VERIFICATION AND CERTIFICATION REPORT

86 MW Hydro Project in Himachal Pradesh

Report No: CCP.VOL0908 MP01 (CP2)

Date: 17-12-2012

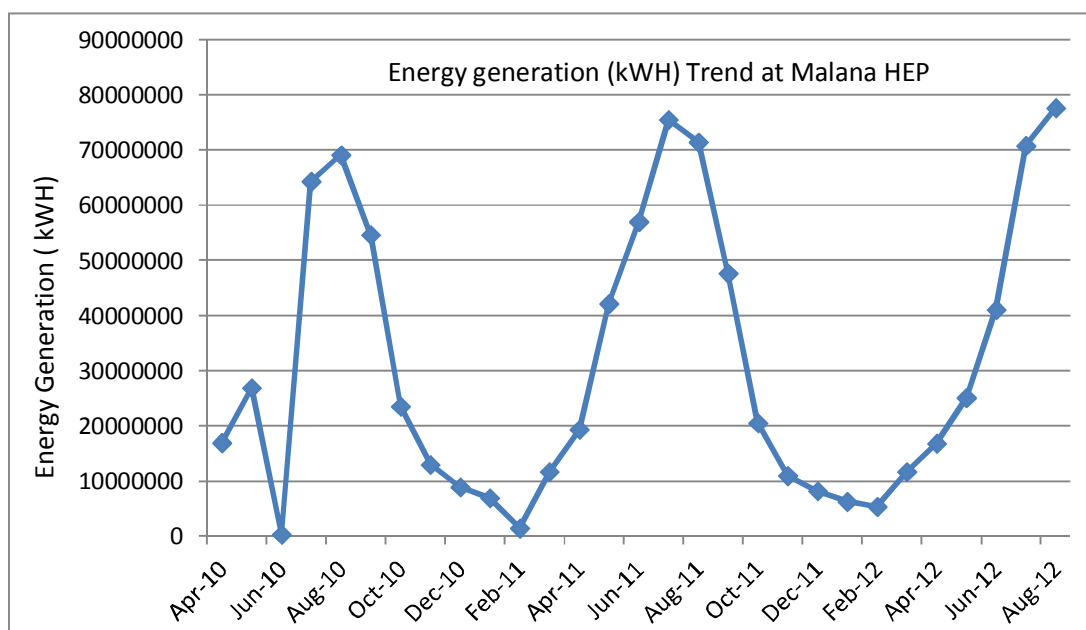
Date:	19/09/2012		Raised by:	Assessment Team	
Type:	CAR	Number:	03	Reference:	AU4
Lead Assessor Comment:					
As per section 5.3 of MR, it is found that the actual VCUs generated during the current monitoring period is in excess (more than 28%) as compared to the estimated emission reductions in the VCS PD version 03, dated 20/03/2012 (Revalidated for the renewable in the crediting period) for the same duration (equivalent to the no. of days in this monitoring period). PP is requested to demonstrate the same with the help of verifiable evidences.					
Project Participant Response:				Date : 11/10/2012	
Difference between estimated VERs in PD and actual generated VERs (tCO2e) is 77916 (-28.28%) on yearly basis. This difference is due to higher PLF achieved during the current monitoring period which is primarily because of two peak season (July-August) covered during current verification period.

Comparing the emission reductions of the immediate one year (Sep 11- Aug 11), the actual emission reductions are 5.44 % higher then what has been estimated for the complete year. The actual emission reductions for the complete one year (Sep 11 – Aug 11) are 290526 as compares to estimated emission reductions 275532. Higher number of emission reduction could be attributed to higher PLF of the project activity during the monitoring period.					
Documentation Provided by Project Participant:					
Revised MR version 02 dated 03/10/12.					
Data Monitoring and ER computation sheet version 02

Revised MR version 02 dated 03/10/12.

Data Monitoring and ER computation sheet version 02

Historical data (Detail of Energy Generated, Transmitted, consumption & Losses by Malana H.E.P. during Financial Year -2010-11 ,2011-12 and 2012-13)
